# Type II Short Plat Review Staff Report and Decision

**Project Name:** Nielson Short Plat

**Case Numbers:** PLD2015-00032

**Request:** Short plat roughly 2 acres into five residential lots for detached housing in two phases in the R1-10 zoning district

## PROPOSED PLAN

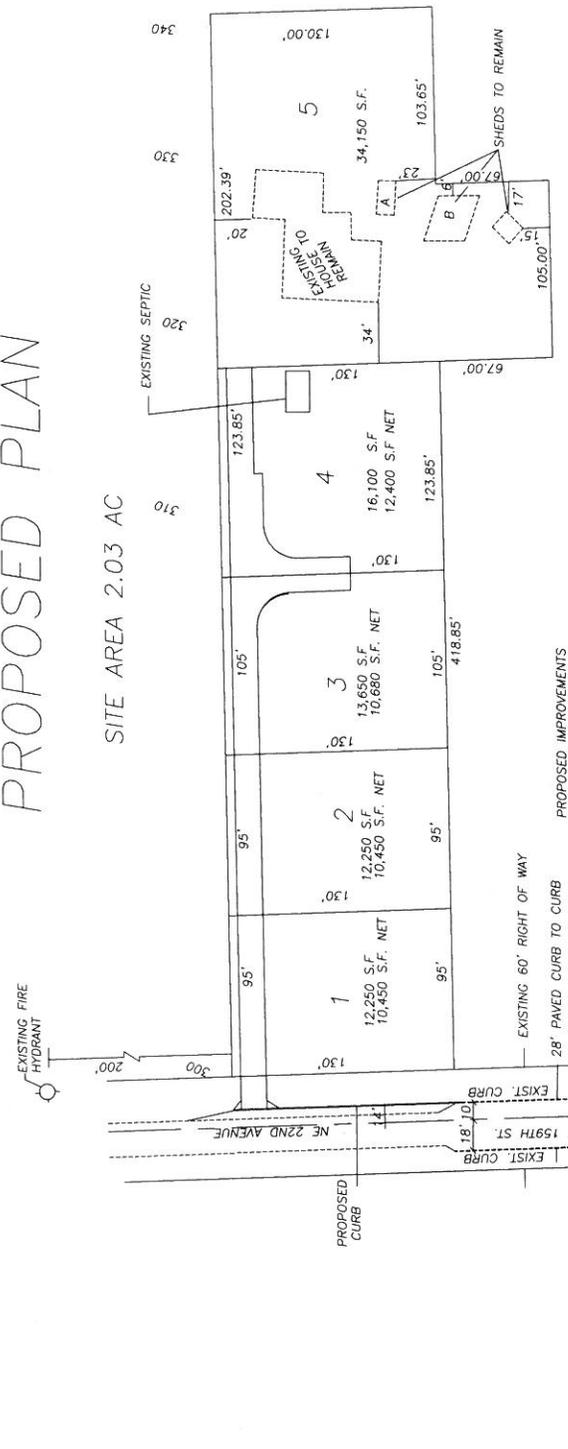
There is an existing residence and three accessory structures located on the site and the applicant proposes to retain the existing residential structures on Lot 5. One of the accessory structures (labeled as B on plan) is six feet from the side property line. Although seven feet is now required by code, five feet was the setback requirement when the structure was built, so it's considered legal non-conforming. The house and the three accessory structures comply with setback requirements of the R1-10 zone.

The applicant has proposed a joint driveway that can serve four of the five proposed lots. A private road is also an option that could be utilized to provide access to all five lots. With a joint driveway, proposed lot #1 will have to access NE 22<sup>nd</sup> Avenue. The applicant has requested the allowance for a sideways hammerhead turnaround via a minor road modification. (See Plat Note C-7c)

The applicant has requested the allowance for a sideways hammerhead turnaround. The applicant believes this request meets criterion CCC 40.550.010(C)(1)(c).

Staff agrees with the applicant that the road modification request qualifies as a minor road modification and that the proposal complies with CCC 40.550.010(C)(1)(c).

The applicant provided a stormwater technical information report dated July 30, 2015. The applicant has proposed a bioretention curb extension as part of the frontage and pervious pavement for the joint driveway. The detention for the homes and individual driveways will be met by construction of a pond or underground storage with control structures for each lot. Per the geotechnical engineering report dated April 14<sup>th</sup>, 2015, prepared by Soil and Water Technologies, Inc. infiltration rates were tested to be 0.5 inches per hour and local well data indicates groundwater to be greater than 100 feet deep. The applicant's geotechnical engineer recommends a minimum safety factor of 2 to be applied to the infiltration rates. (See Condition A-3a)

- A-1 **Final Transportation Plan/On-Site** - The applicant shall submit and obtain County approval of a final transportation design in conformance to CCC 40.350. NE 22<sup>nd</sup> Avenue is an "Urban Local Residential Access" road and the minimum half-width frontage requirements include 23 feet of right-of-way, 14 feet of paved width, curb, gutter, and sidewalk. (See Finding 9)
- A-2 **Transportation:**
- a. Signing and Striping Plan: The applicant shall submit a signing and striping plan and a reimbursable work order, authorizing County Road Operations to perform any signing and pavement striping required within the County right-of-way. This plan and work order shall be approved by the Department of Public Works prior to final plat or final site plan approval.

- A-3 **Final Stormwater Plan** - The applicant shall submit and obtain County approval of a final stormwater plan designed in conformance to CCC 40.385 and the following conditions of approval (see Finding 13):

- a. The proposed bioretention and pervious pavement shall be designed according to the design criteria of the Stormwater Management Manual for Western Washington.

NE 22ND AVENUE SECTION

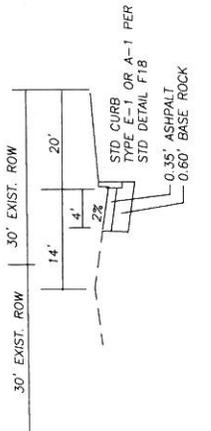
NE 22<sup>nd</sup> Avenue is an "Urban Local Residential Access" road and the minimum half-width frontage requirements include 23 feet of right-of-way, 14 feet of paved width, curb, gutter, and sidewalk (see Condition A-1).
